Sandia National Laboratories

DOE/Sandia Responses to NMED's "Notice of Disapproval: Mixed Waste Landfill Corrective Measures Implementation Report, January 2010"

Comments and Responses for the Mixed Waste Landfill Corrective Measures Implementation Report

Figure 2-5
Schematic MWL-MW4 PVC Well Casing and Protective Surface Casing Extension Diagram

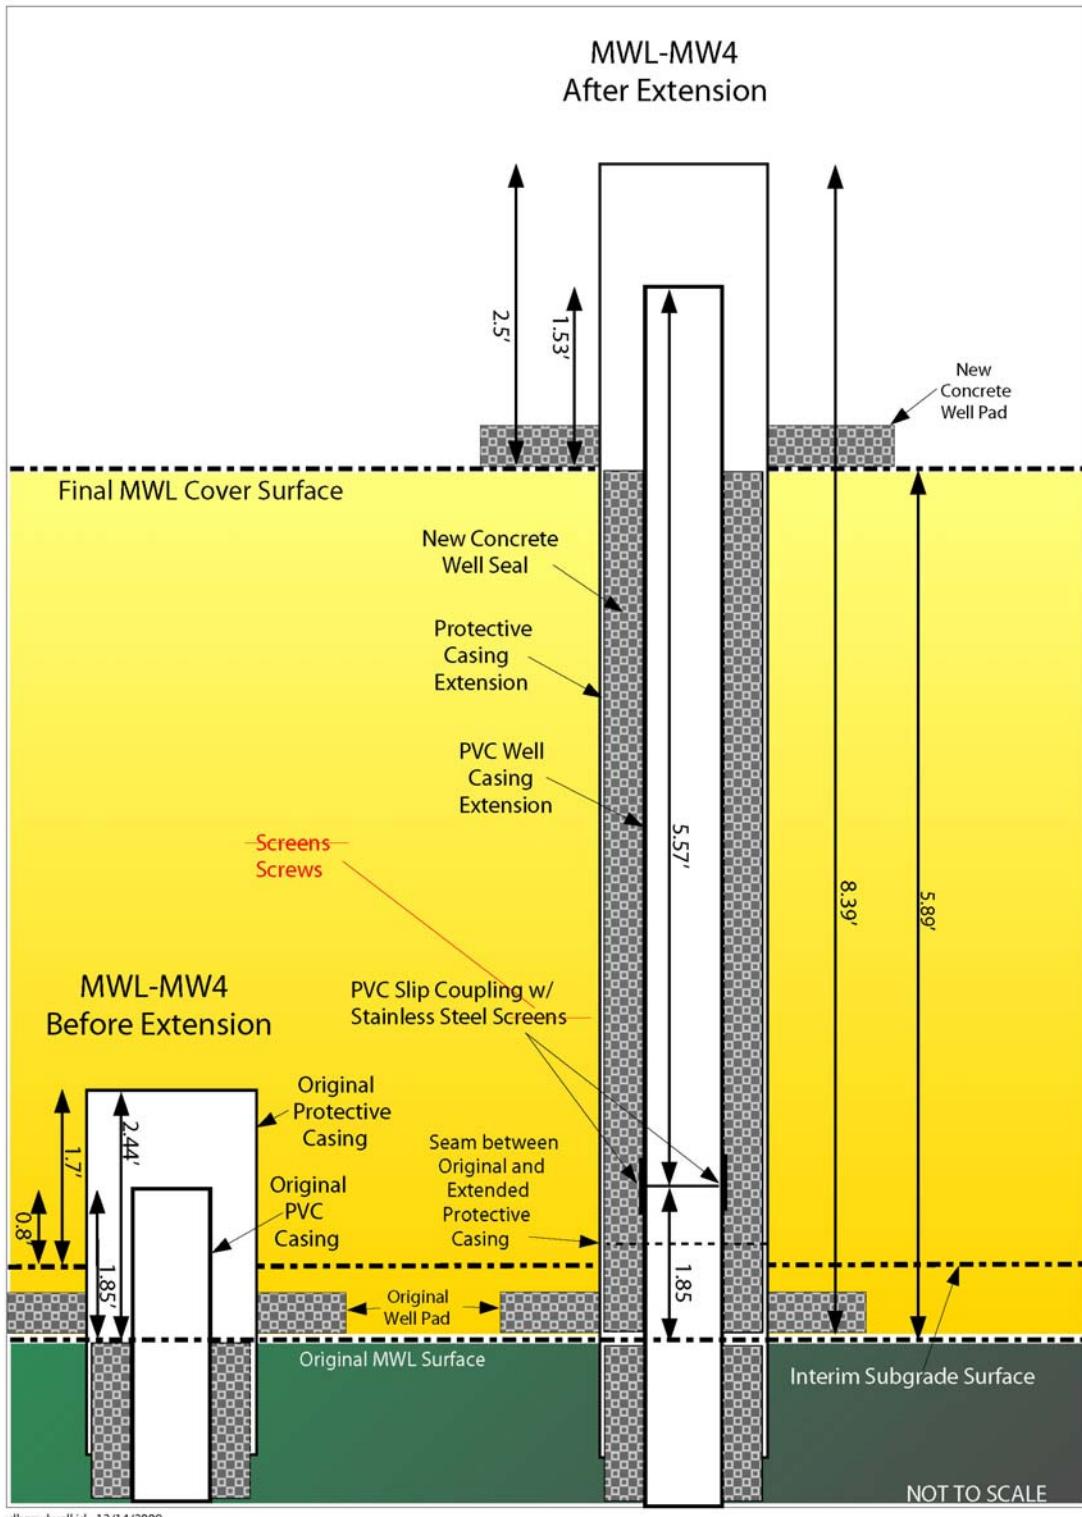
CQA Report, Attachment 8, Figure 2-5, center of figure: "PVC Slip Coupling w/ Stainless Steel Screens" should read "PVC Slip Coupling w/Stainless Steel Screws".

Also in Attachment 8, Section 3, first bullet provides justification of the "double anchored" well resulting from not demolishing the original well pad. The Permittees should carefully monitor and observe the upper 10 feet of the interior casing during future sample events to monitor whether this arrangement causes damage to the well casing from potential settlement of underlying waste.

Response: The error in Figure 2-5 of Attachment 8 in the CQA Report (Appendix A of the CMI Report, Volume 2), has been corrected. The associated revision to the CQA Report is tracked in Table 1 and documented in redline-strikeout format in Attachment 1. Attachment 2 of this comment response document provides the replacement page, and the revised figure is incorporated into the electronic version of the CMI Report (January 2010, Revision 1) provided on both CDs.

In addition, DOE/Sandia will inspect the upper 10 feet of the interior casing during future sampling events to monitor whether this arrangement causes damage to the well casing from potential settlement of underlying waste.
